Technical Service Bulletin – 03

Mustang Dark Horse R Engine Cooling - Ducting

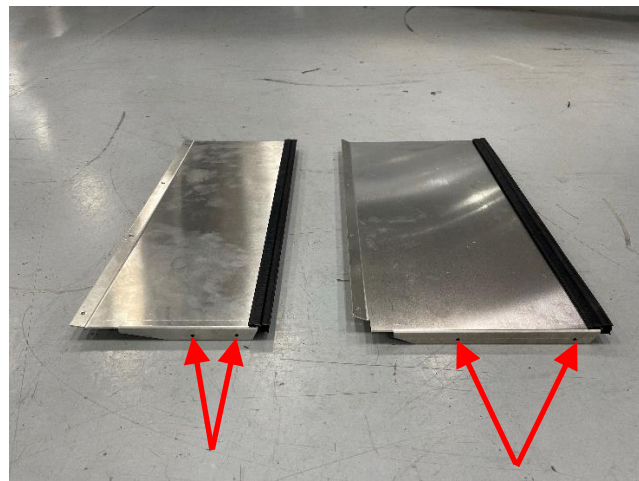
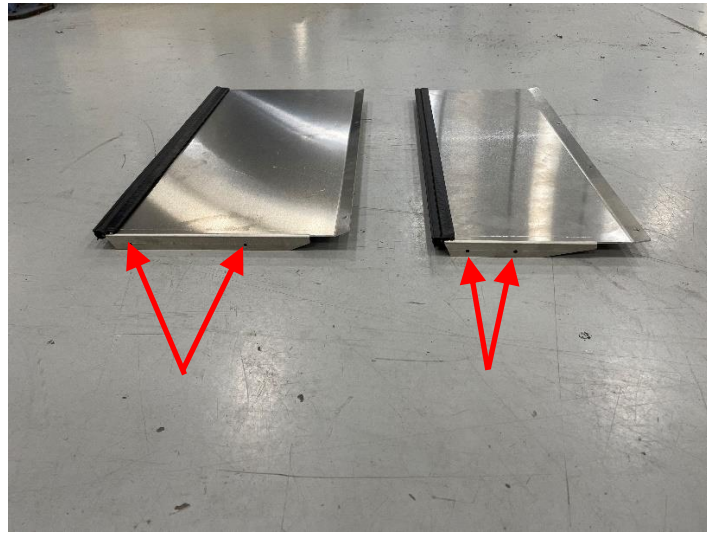
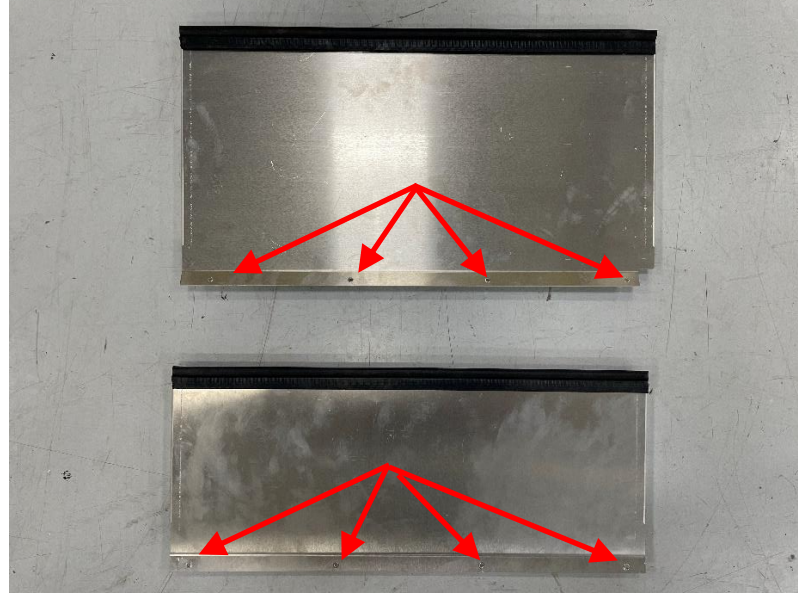
Issue: Some Mustang Dark Horse R's have experienced high engine coolant temperatures on track.

Action: Follow the procedure to remove the ducting above and below the engine oil cooler.

- Remove the front fascia
- Drill out the rivets on the ducts
 - Upper Duct
 - Remove the 4 rivets on the long side near the front
 - Remove the 2 rivets on both the right and left hand sides
 - Remove the upper duct
 - Lower Duct
 - Remove the 4 rivets on the long side near the front
 - Remove the 2 rivets on both the right and left hand sides
 - Remove the lower duct
